Technical Bulletin

**Subject: Bendix® Intellipark® Parking Brake System Recall**

Bendix Commercial Vehicle Systems LLC (Bendix) is conducting a voluntary safety recall campaign, **Recall No.: 21E070,** involving the Bendix® Intellipark® Parking Brake System's Dash Electronic Control Unit (DECU).

Figure 3 – Intellipark DECU Date Code Interpretation

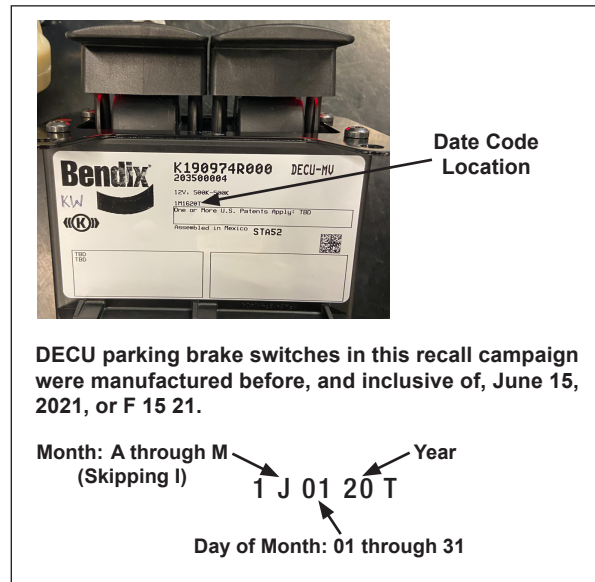
See Figure 3. A date code is displayed on the Bendix® Intellipark® Dash Electronic Control Unit (DECU) label which is located on the underside of the switch's Electronic Control Unit (ECU). Locate the label on the DECU to read the date code. The portion of the date code that determines the date of manufacture can be interpreted as follows:

DECU parking brake switches in this recall campaign were manufactured before, and inclusive of, June 15, 2021, or F 15 21.
